ADDENDUM TO THE CONCEPTUAL DRAINAGE STUDY UPDATE NO. 3

Kyle Canyon Gateway

**Subject: Addendum to the Conceptual Drainage Study Update No. 3 for
Kyle Canyon Gateway (CLV# DS5414)**

CITY OF LAS VEGAS		DATE:
INTER-OFFICE MEMORANDUM		April 1, 2022
TO: Land Development Services Department of Building & Safety		FROM: Oh-Sang Kwon, P.E. Flood Control, Project Manager Department of Public Works
SUBJECT:	Drainage Study for:	COPIES TO:
Conceptual Drainage Study – Kyle Canyon Gateway		Westwood PS
Cross Streets:	Alpine Ridge Way & Kyle Canyon Road	Tri Pointe Homes
File Number:	F:\Depot\DSMemos\DS5414F.doc	Bart Anderson, P.E., DevCo
Parcel Number:	Various, 12601601..., 12601501..., etc.	CCRFC
Zoning Action:	N/A	
FEMA Flood Zone	YES NO X	
Proposed Storm Drain	YES X NO

KYLE CANYON GATEWAY PHASING ORDER

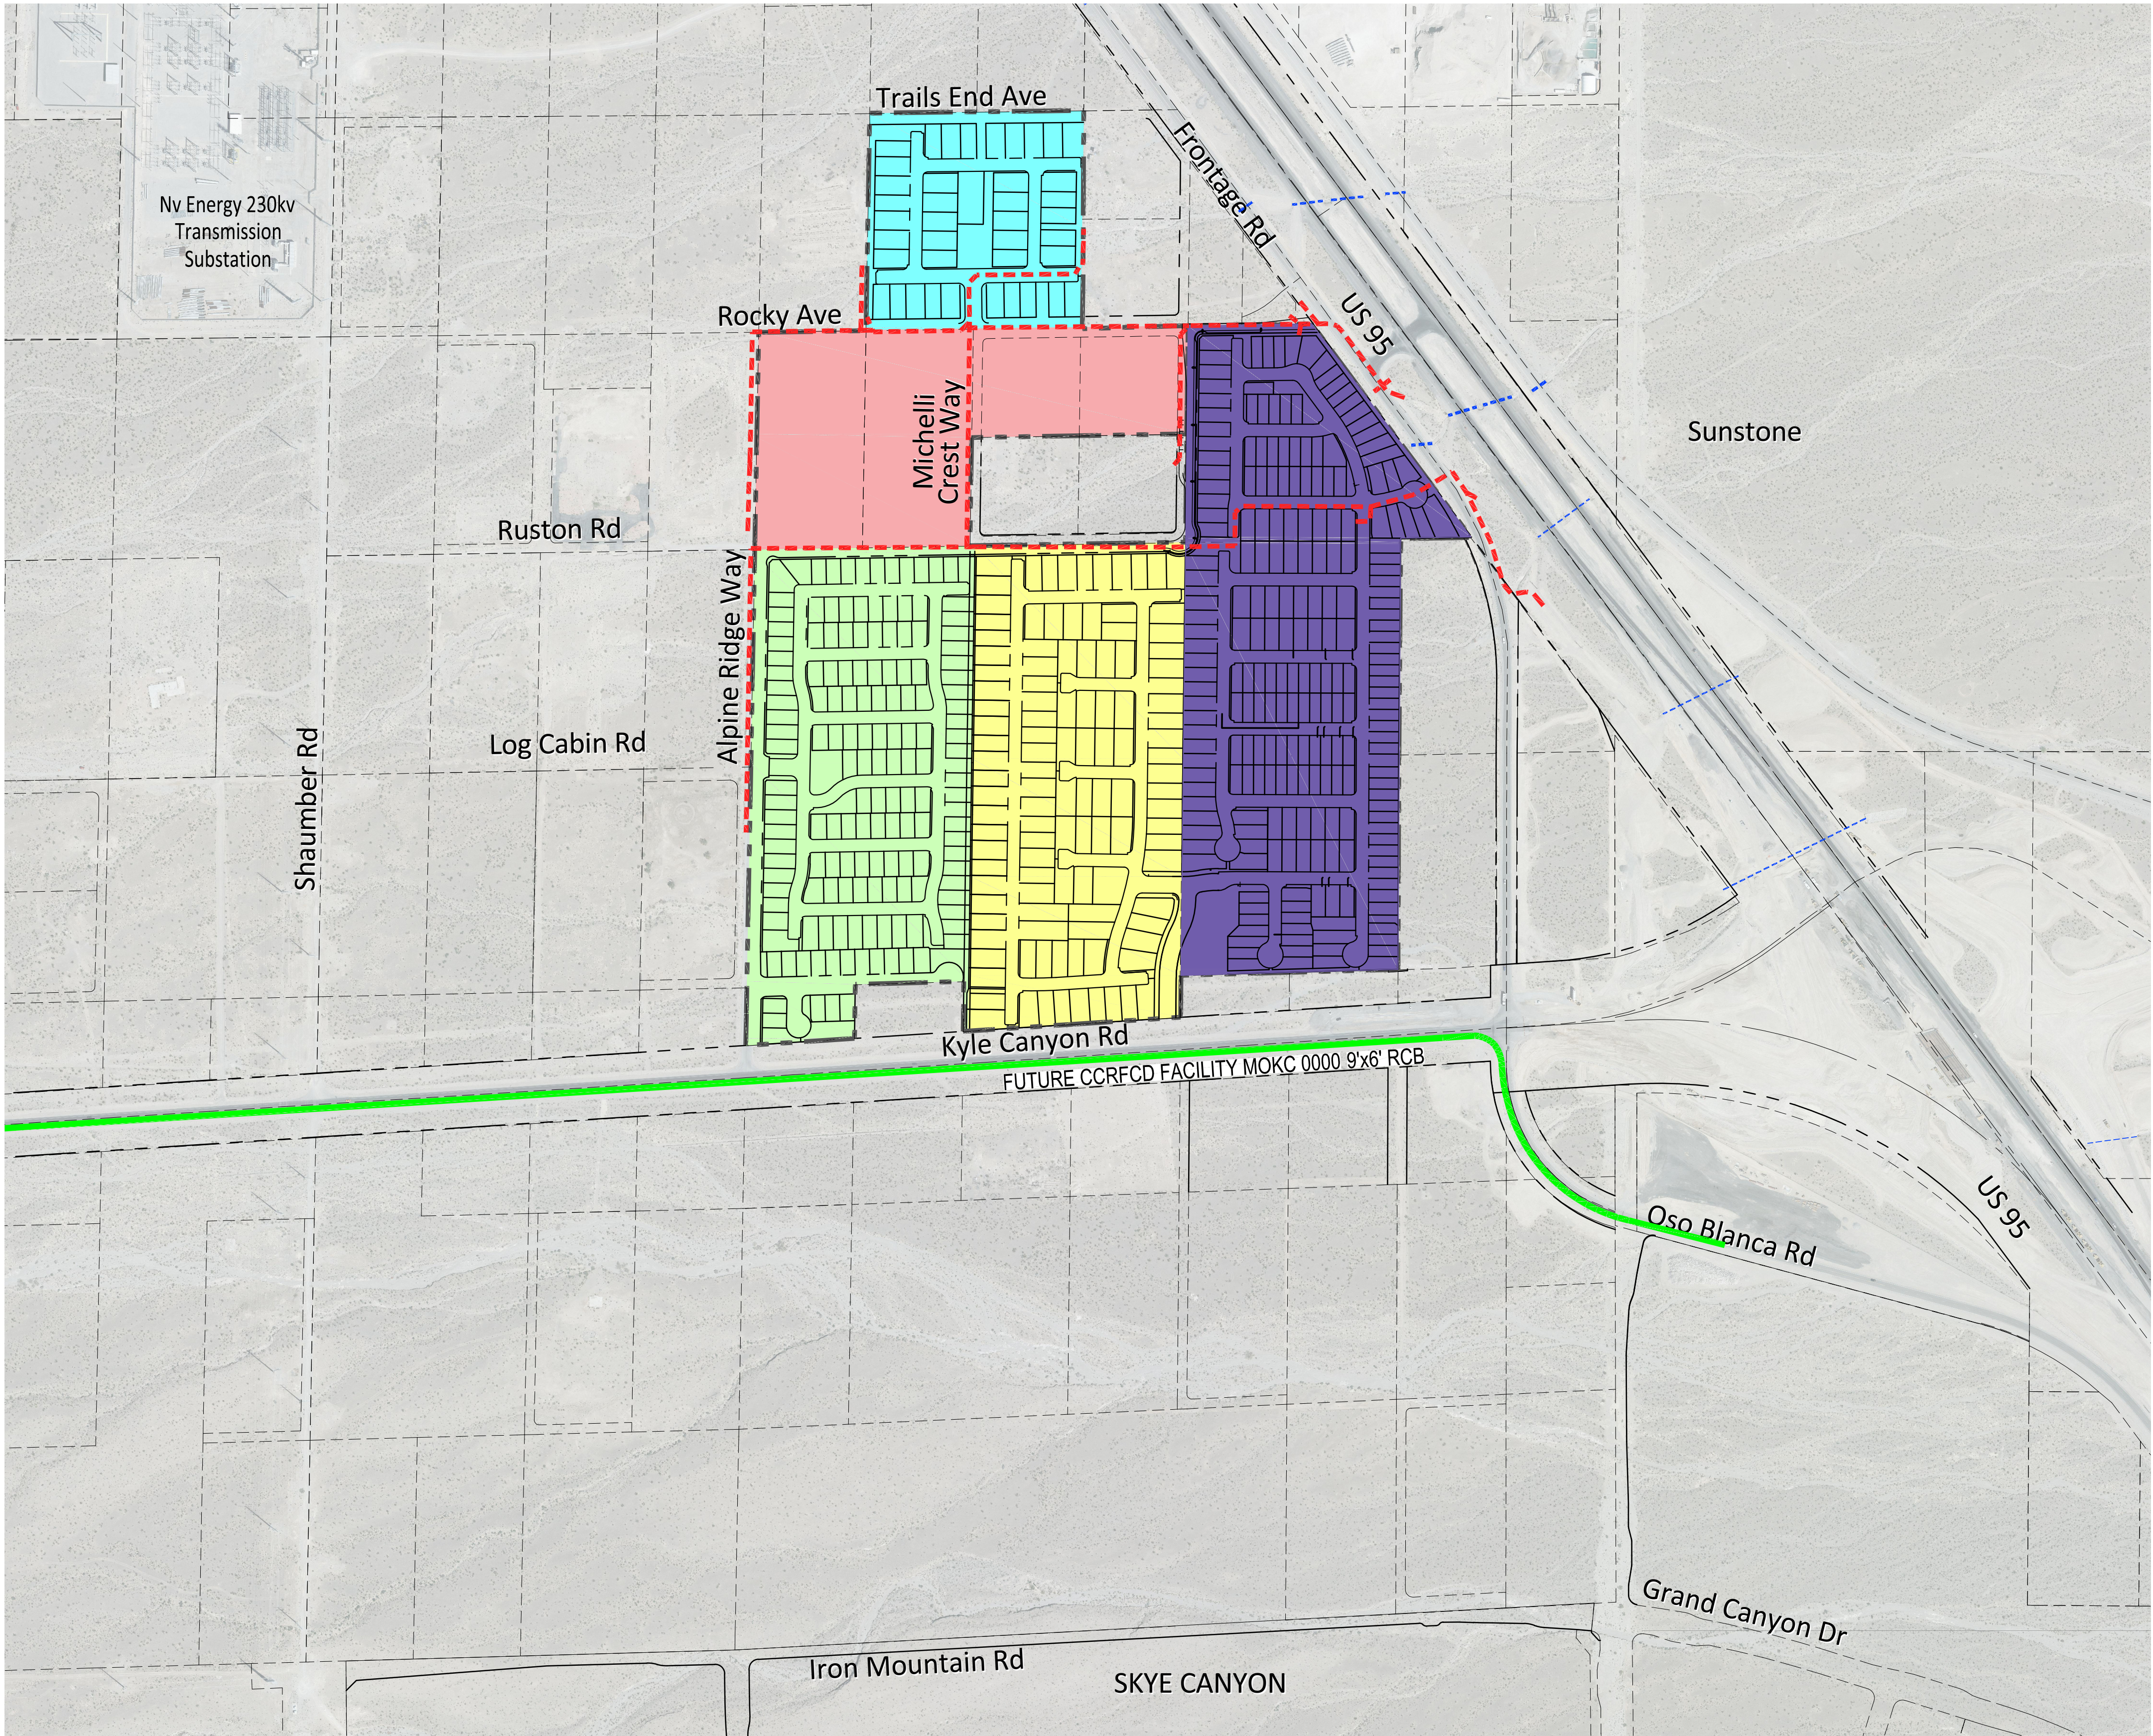
5. **Comment:** *Update the Phasing Plan for the Proposed Condition facilities necessary for each Unit as part of Exhibit F. The impacted area of Future Unit #4 needs to include both Concept and Future (Ultimate) facilities.*

5. Update the Phasing Plan for the Proposed Condition facilities necessary for each Unit as part of Exhibit F. The impacted area of Future Unit #4 needs to include both Concept and Future (Ultimate) facilities.

Response: A phasing plan is provided with this addendum, see Appendix B. Note that this is the preferred phasing order for the developer, but that this phasing plan is subject to schedule constraints of individual phasing, sometimes due to circumstances outside the developers control.

Response: Phasing plan included with this conceptual update addendum, see Appendix B.
